DeKalb County Zoning Board of Appeals

Planning Department Staff Analysis

D1. Case No: A-26-1248106

211 S Howard Street - Townhome Development

SITE PLAN

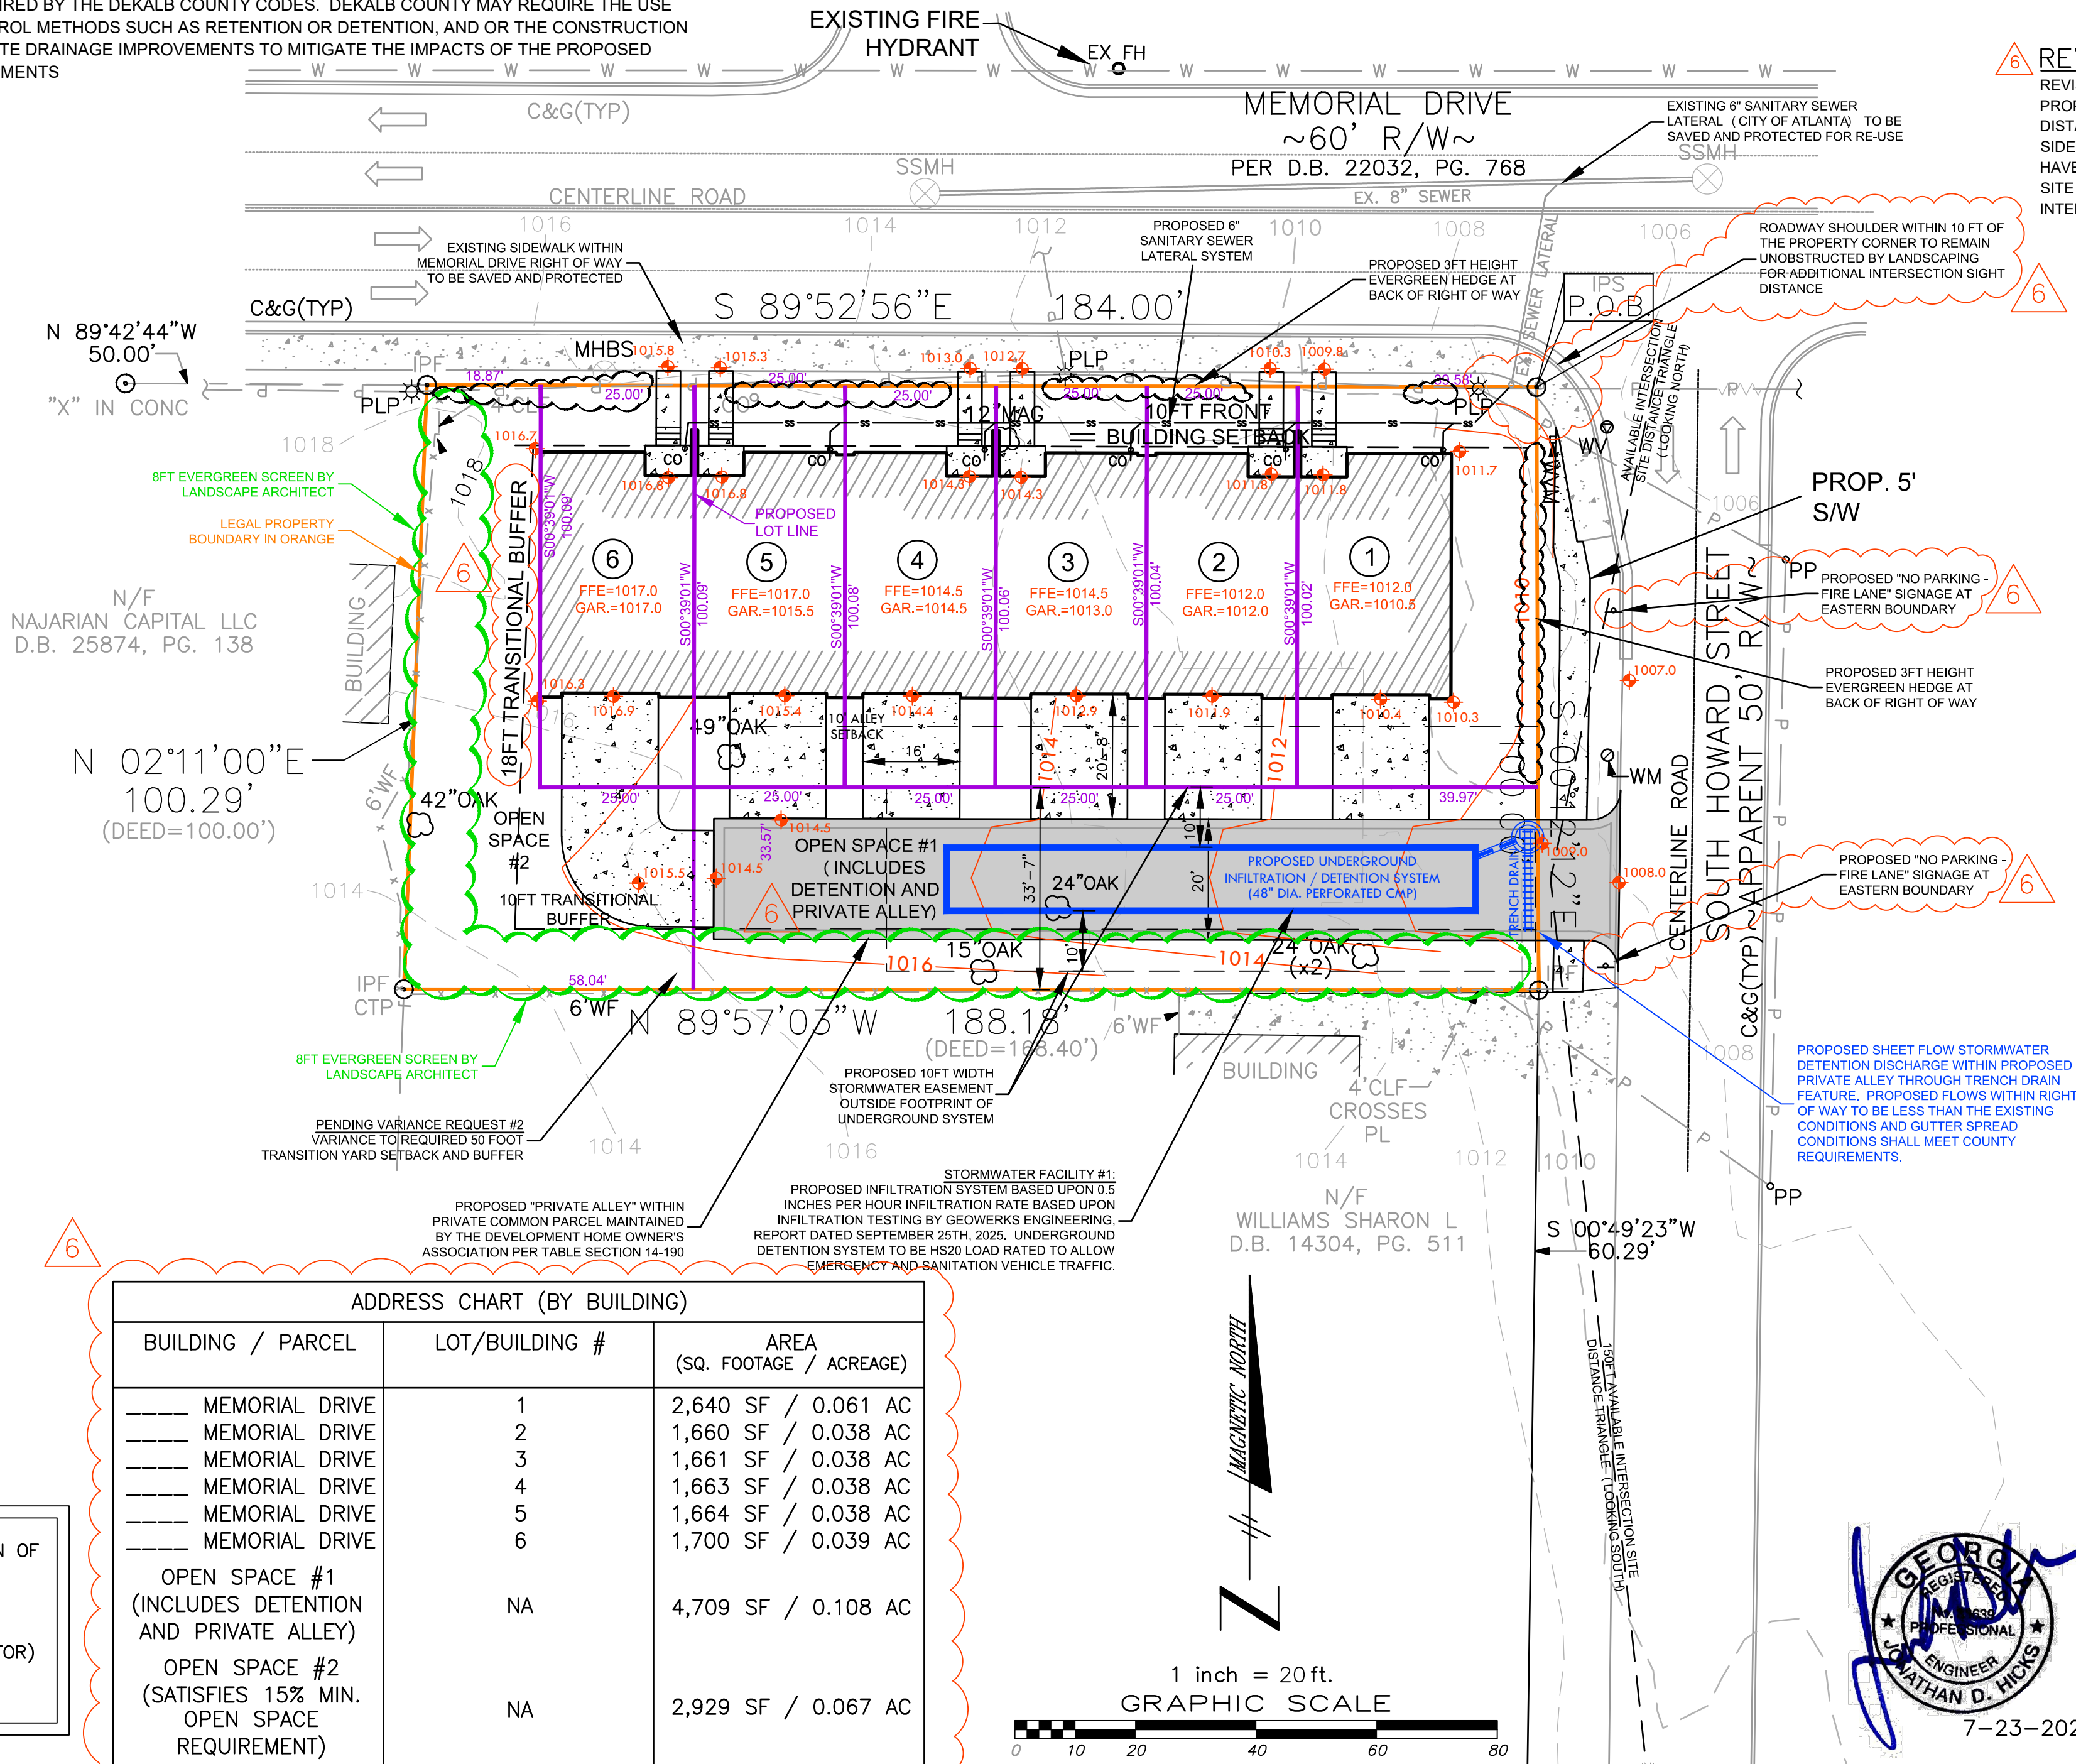
The submitted request appears to go beyond the minimum necessary to afford relief. Staff further acknowledges that strict application of 50-foot buffers along both affected sides of the property would be heavily imposing on a constrained corner-lot site and that some reduction may be necessary to allow reasonable use of the property. However, there may be an opportunity to reduce the extent of the requested variances by reducing the number of proposed units, modifying the site layout, or otherwise revising the development program to better fit the dimensional limitations of the property.

Staff acknowledges that the request has been reduced regarding the southern transitional buffer, however the request regarding the western transitional buffer had been increased by an additional five feet from the previous hearing.

However, the submitted request appears to exceed the minimum relief necessary. While the site may warrant some variance relief, the scale of the requested variances indicate that the proposed development may be over-programmed for the lot. There may be an opportunity to reduce the requested relief through a reduced number of units, revised site design, or a development program that better responds to the property's constraints and the adjacent R-75 single-family residential context.

REVISION #6 INCLUDES A 10 FOOT SHIFT WEST OF THE PROPOSED TOWNHOME UNITS TO PROVIDE ADDITIONAL DISTANCE BETWEEN THE UNITS AND THE THE SOUTH HOWARD SIDEWALK. ADDITIONAL LANDSCAPE AND SIGNAGE REVISIONS HAVE BEEN MADE TO ALLOW FOR ADDITIONAL INTERSECTION SITE DISTANCE AT THE SOUTH HOWARD AND MEMORIAL DRIVE INTERSECTION.
